**DRAINAGE LETTER ADDENDUM FOR
ACADEMY GATEWAY SUBDIVISION NO. 1**

RE: Drainage Letter Addendum for Academy Gateway Subdivision Filing No. 1

ACADEMY GATEWAY SUB. FIL 1
ADDENDUM
JOB NO. 2507.00
AUGUST 9, 2017
SHEET 1 OF 1

DRAINAGE MAP

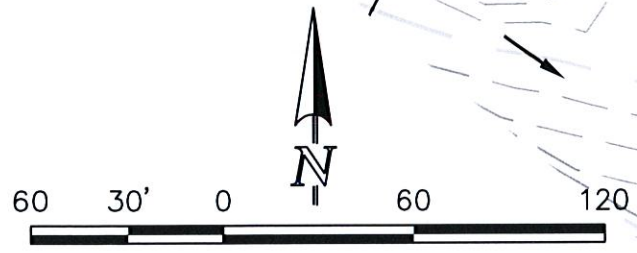
This letter will update storm sewer routing inlet sizes and alignment for Academy Gateway Subdivision Filing No. 1 Lot 1 and Lot 2. More specifically Basin D. Please see the "Preliminary/Final Drainage Report for Academy Gateway Subdivision Filing No. 1" by CCES approved July 6, 2017 report for drainage information. All basins and drainage patterns from the original report remain the same as previously approved with the exception of Design Points 2 & 4 and Basins B & D on attached drainage map excerpt.

Design Point 2 ($Q_5 = 5$ cfs, $Q_{100} = 8$ cfs) is the proposed developed flow from Basin B which is predominately the paved surface of Academy Gate View. A proposed private 5' Type R sump inlet will intercept these flows in their entirety. Basin B area has increased from 0.99 acres to 1.08 acres with the addition of a high point in in the access roadway adjacent to Lot 1 and Lot 2. No impact to proposed inlet sizing or developed flows.

Design Point 4 and Basin D from the approved report is further broken down based upon future use of Lot 1 and Lot 2. Basin D is broken down into Basins D, D1, D2 D3 and D4 with associated Design Points 4 and 4A for inlet and pipe sizing. Design Point 4 ($Q_5 = 0.1$ cfs, $Q_{100} = 3$ cfs) consists of flows from Basin D4 which is private drive aisle. A proposed 5' Type-R inlet will intercept flows. Design Point 4A ($Q_5 = 0.1$ cfs, $Q_{100} = 3$ cfs) consists of flows from Basin D2 which is private drive aisle between Lots 1 and 2. A proposed 5' Type-R-at grade inlet will intercept flows. Basin D ($Q_5 = 4$ cfs, $Q_{100} = 6$ cfs) consists of future commercial use on Lot 1. Flows will be captured onsite and routed to a provided 18" storm sewer stub (Pipe 5). Basin D3 ($Q_5 = 2$ cfs, $Q_{100} = 3$ cfs) consists of future commercial use on Lot 1. Flows will be captured on site and

routed to a provided 12" storm stub. Basin D1 ($Q_5 = 4$ cfs, $Q_{100} = 7$ cfs) consists of future commercial use on Lot 2. Flows will be captured onsite and routed to a provided 18" storm sewer stub (Pipe 3). All flows will be routed to the proposed Detention Facility A as previously designed. Per original report Basin Design Point 4 was ($Q_5 = 10$ cfs, $Q_{100} = 18$ cfs) and was routed to the detention facility in a proposed 24" Storm system. This is comparable to Pipe 6 ($Q_5 = 10$ cfs, $Q_{100} = 18$ cfs) in this addendum. No increase in developed flows is anticipated.
